2 December 2025

REF: WTJ24 -549

**RE: AMENDMENT TO SSD-80018208 – PROPOSED DATA CENTRE
PROPERTY AT 6-8 JULIUS AVENUE, NORTH RYDE (LOT 89 DP1082131)**

Figure 1. Amended Site Plan (Source: Greenbox Architects, 2025)

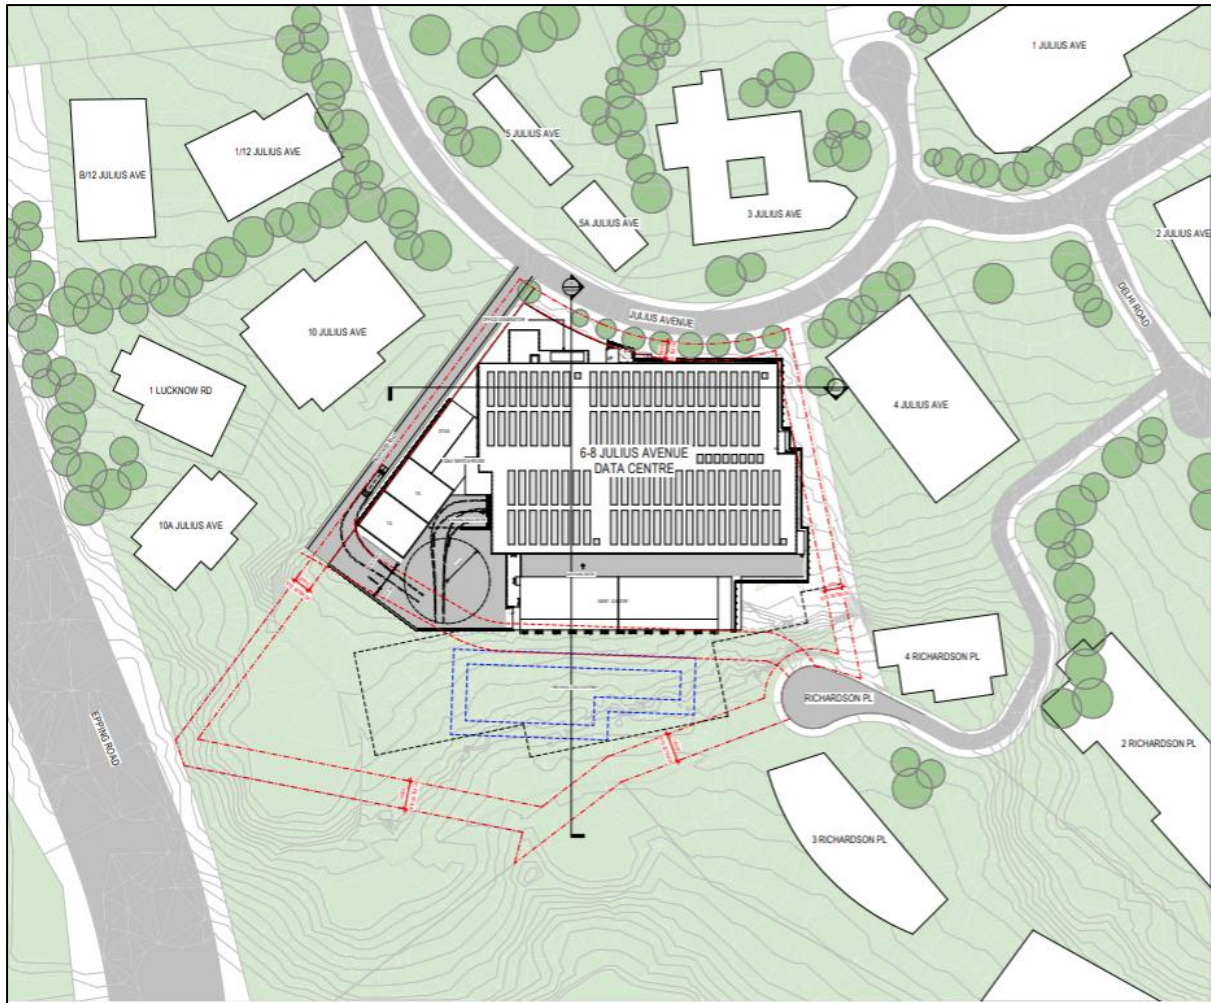
The development now has a reduced facility capacity (approximately 76MW, from 115.2MW) thus reducing consumption demands. Further, an amendment to the cooling methods of the facility has been proposed, with an adoption of air-cooled chillers, rather than the water-cooled chillers previously included. **TABLE 1** below summates the changes to operational measures of the proposed development.

A reduction in capacity and the change to cooling methods allows the deletion of the former Level 6 chiller and deletion of the former basement level (as water storage tanks are no longer required).

TABLE 1. PROPOSED CHANGES		
Item	Previously Proposed	Proposed Through Amendment
Capacity	115.2MW	76MW, a reduction of approximately 34%.
Cooling Method	Water-cooled chiller level with rooftop cooling towers.	Single rooftop level comprising of air-cooled chillers.
Number of Storeys	6 storeys	4 storeys
Gross Floor Area (GFA)	26,076m ²	16,647m ²
Car parking	Basement level	Ground level

Figure 2. Ground Floor Car Parking Area (Source: Greenbox Architects, 2025)

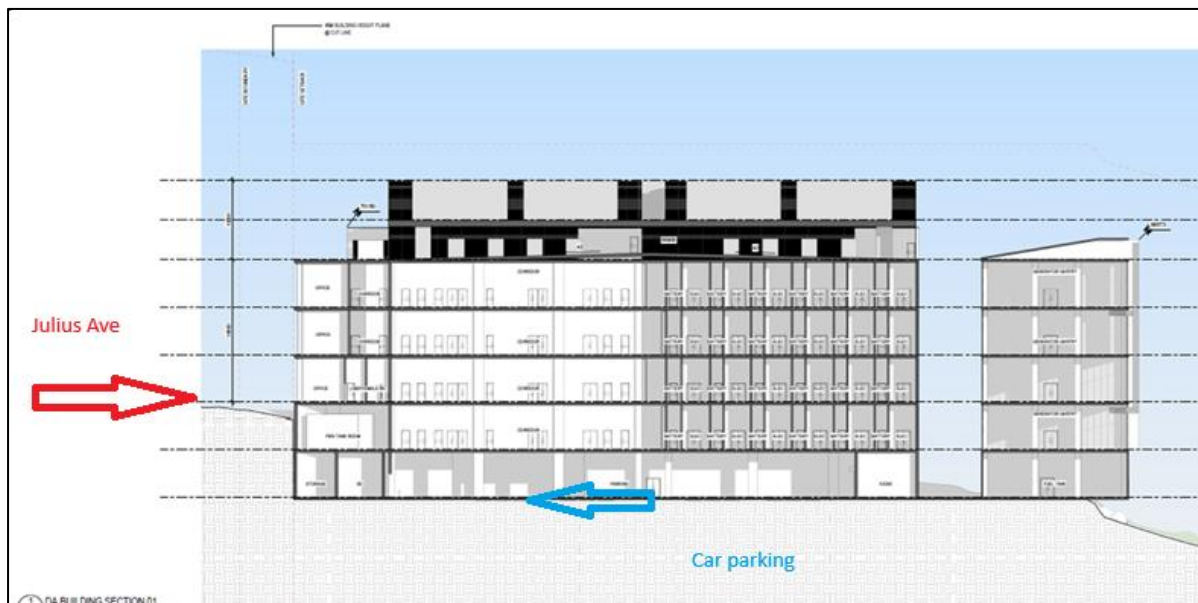
Basement car parking has been relocated to the ground level adjacent to the proposed loading dock. As the site is zoned E3 under the RLEP 2014, Clause 6.7 applies, restricting ground floor development to commercial activities, and parking would be inconsistent with this requirement. The City of Ryde highlighted this technicality and provided advice that the parking is at ground level but not perceivable from street level due to the site's topography, and is therefore considered acceptable. The site has undergone major earthworks, with the actual ground floor situated more than 12 metres below Julius Avenue and aligning with the existing cut level.

City of Ryde has confirmed the approach of using the ground floor for parking is generally suitable. This amendment also seeks endorsement from DPFI for a future Clause 4.6 Variation Request on this basis.

Figure 3. Location of STSS (Source: Greenbox Architects, 2025)

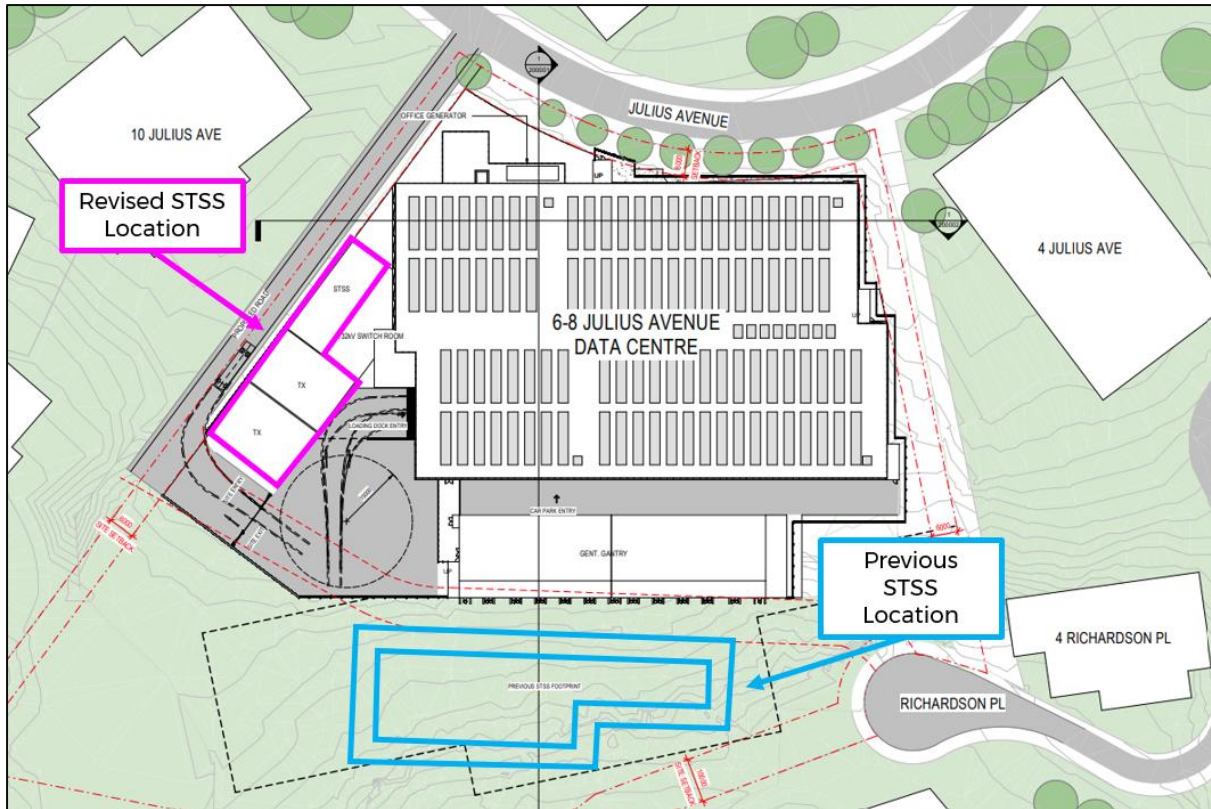
As a result of the reduction in capacity identified above, there is a reduction in demand to the sub-transmission switching station (STSS) is reduced, allowing for the STSS to be located to the west of the building, rather than its former location which was located in a separate area to the south.

TABLE 2. CHANGES TO STSS		
Item	Previously Proposed	Proposed Through Amendment
Capacity	120MW	180MW
Location	Separated to the south of the proposed building.	Adjacent to the building to the west.

The justification for the relocation of the STSS is primarily centred around the reduction of clearing of vegetation on the subject site, as identified throughout submissions regarding the proposed development. The STSS will remain accessible by Ausgrid from an access road and shared driveway from Julius Avenue. This arrangement has been tabled with Ausgrid, which have verbally endorsed this approach.

Figure 4. Proposed Removal of Richardson Place Extension (Source: Greenbox Architects, 2025)

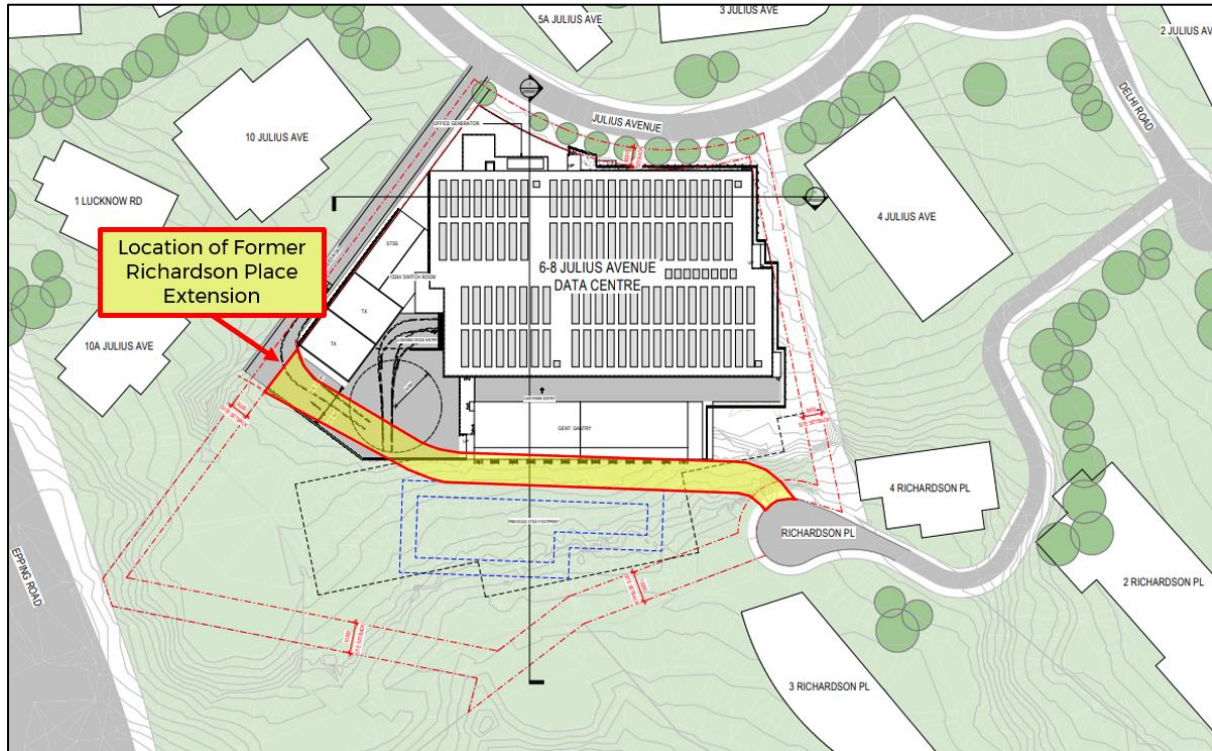
The proposed development now removes the previous extension of Richardson Place. This was proposed to extent from the existing cul-de-sac to an additional juncture point creating an additional connection to Julius Avenue. However, this resulted in additional vegetation clearing on the subject site and removal of the existing vehicular spaces benefitting tenants of 3 Richardson Place (Lot 12 DP876736).

The road connection provided was initially provided in alignment with the Macquarie Park Innovation Precinct Design Guide (Design Guide). However, due to additional areas of vegetation clearing and resulting in a larger scale of development, the road connection has been removed from the scope of works of this development. This ensures on-site vegetation is beneficially retained and does not preclude such a connection being constructed in future, however, justifies its current removal from the scope of works. The relocation of the STSS also negates the present requirement for this road due to its relocation to the west of the building.

Figure 8. Proposed Removal of Western Walking Track (Source: Arcadia, 2025)

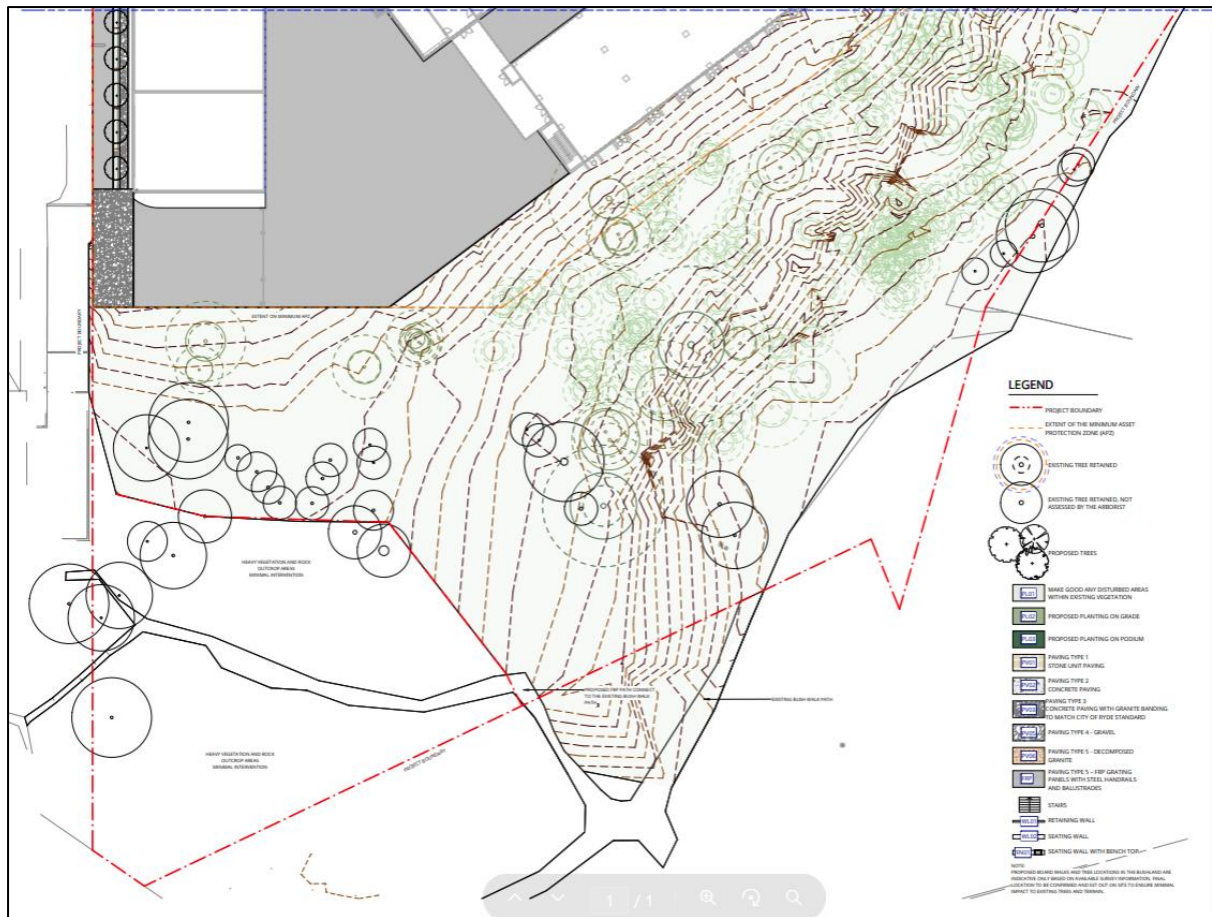
The previously proposed walking track on the western side of the subject site has been removed from the proposed development due to the absence of such a requirement under the Design Guide. Further, discussions have been undertaken with Friends of Lane Cove National Park. Through these discussions, it was confirmed that there was a preference to avoid disturbance by the retention of existing bushland rather than the provision of an additional pedestrian connection. Notwithstanding, the pedestrian link path to the rest of the subject site will be maintained.

The removal of the western walking track was a direct response to the concerns raised by Friends of Lane Cove National Park, particularly with their preference to retaining bushland rather than an additional pedestrian connection. Notwithstanding, there still remains a pedestrian connection point through the site between Julius Avenue and the Great North Walk, towards the eastern extent.
